VILLAGIO CR BLDG#1022 UNITS 1-12

Nature of Work: NEW APARTMENT #1022 TYPE 1

RE: Villagio Apartments  
RFI #47

RE: Villagio Apartments  
RFI # 33

VILLAGIO APTS.	Project No. 21107
MISSING SILL FP CORRECTION DETAIL	Date 11/7/02
RFI #02	Sheet 2 of 2

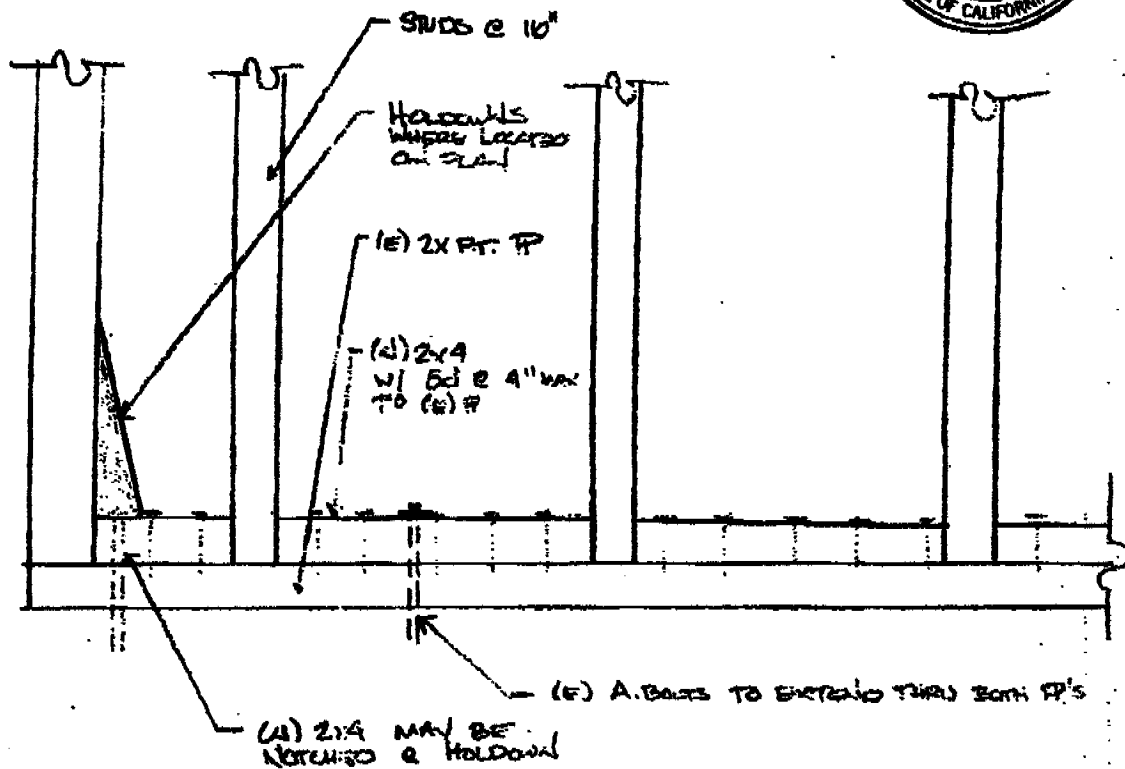
- 5. FRAMING, N
  - a. 14" TJI PLK AT PERP TO GREAT VERITY 5;
  - b. ROOF TRUS MAXIMUM.
- 6. STYRUM BOA
  - a. 1/2" STYRU (5/8" WITH
  - b. 1/2" TYPE (5/8" TYPE
  - c. 5/8" TYPE
  - d. 5/8" TYPE
  - e. 1/2" TYPE
- 7. RESILIENT CH
- 8. WALL INSULAT (SECTION TC)
- 9. FLOOR CEILIN
- 10. ROOF CEILING
- 11. FIRESTOPPING HORIZONTAL
- 12. 2X STUDS AT
- 13. 2X JOISTS.
- 14. 2X BLOCKING.
- 15. DOUBLE SILL F
- 16. 2X CEILING JO
  - a. METAL PURR (PER U.S.C. :
- 17. 2X NAILER

VILLAGIO APTS		Project No. 21107
TRUSS BLK DETAIL @ ERLO HIP JACK TOP CHORD		Date 11/14/02
		Sheet 2 of 2

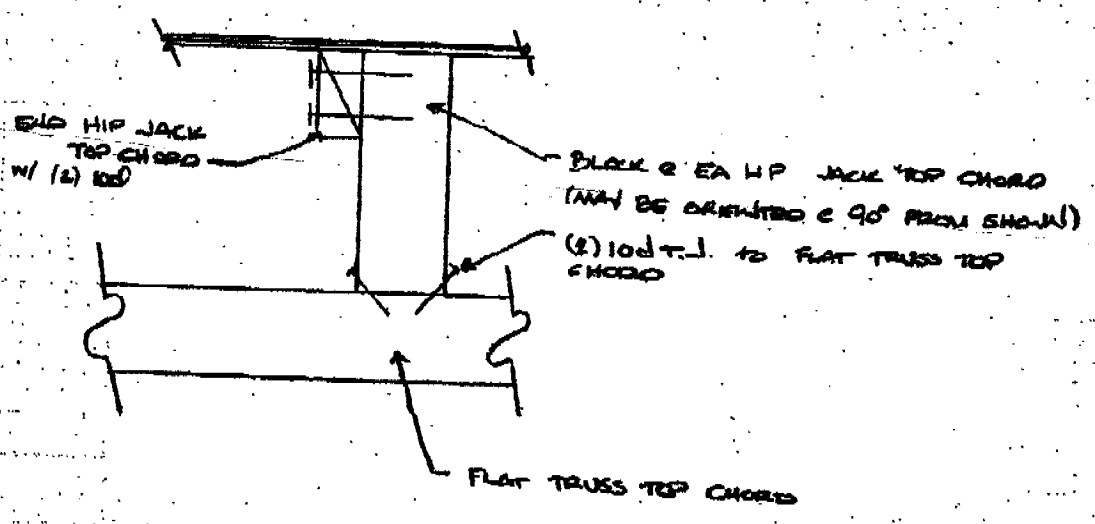
FOR ALL OTHER CALL-OUTS SEE  
WALKER LUMBER DETAILS
